January 2019
FL800A
NHTSA #18V-787
Transport Canada #18-624

Subject: Cascadia Steering Wheel Airbags

Models Affected: Specific Freightliner Cascadia vehicles manufactured August 3, 2017, through October 31, 2018.

The wiring leading to the steering wheel clockspring will be modified, the clockspring will be replaced, and correct grounding will be ensured.

Fig. 3, Steering Wheel Cover Module, Steering column and Clockspring.

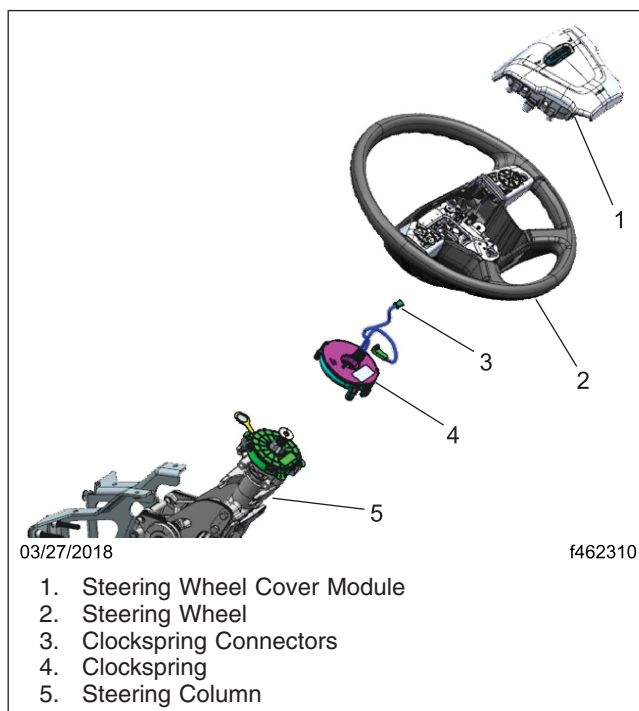
15.3 Disconnect the clockspring connector from the right hand (RH) switch pod. See [Fig. 3](#)

15.8 Install the new clockspring, but do not connect it to the dash wiring.

15.9 Tighten the clockspring capscrews to 10 lbf-in (113 N-cm) +/- 1 lbf-in (11 N-cm).

Fig. 4, Diode Harness Wrapped with Fiber Wrap

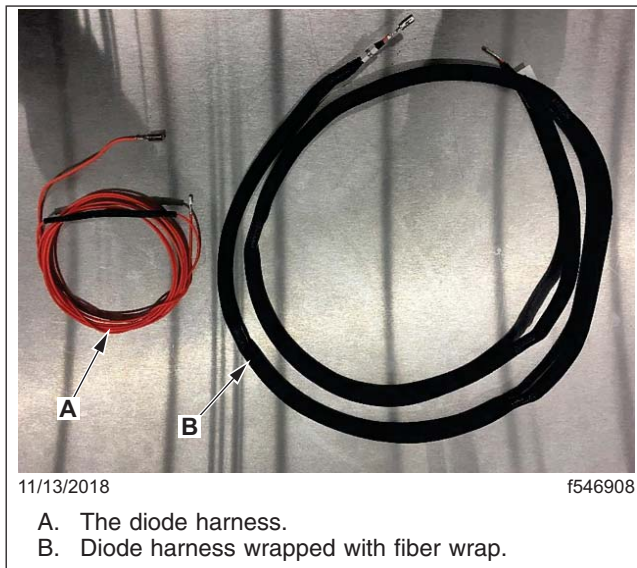
16.1 Before installing the diode harness, make sure that the harness is wrapped with fiber wrap. See [Fig. 4](#).

Fig. 5, ASAM Connector Map

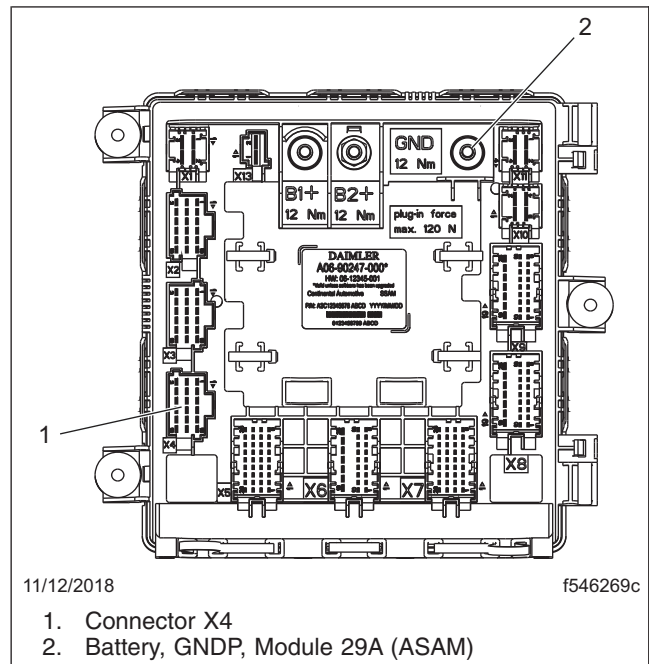
16.2 Disconnect connector X4 on the ASAM. See [Fig. 5](#).

16.3 Insert the diode circuit into connector X4, pin 6.

Fig. 7, Diode Harness Plugged into the Clockspring Connector

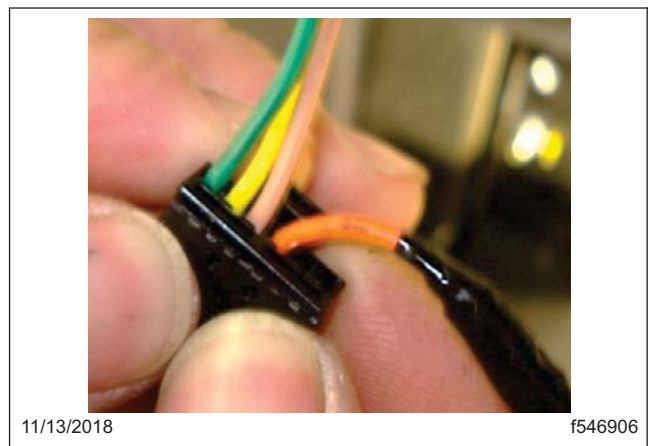
16.7 Insert the terminal from the diode harness into cavity 4 of the clockspring connector. See [Fig. 7](#).
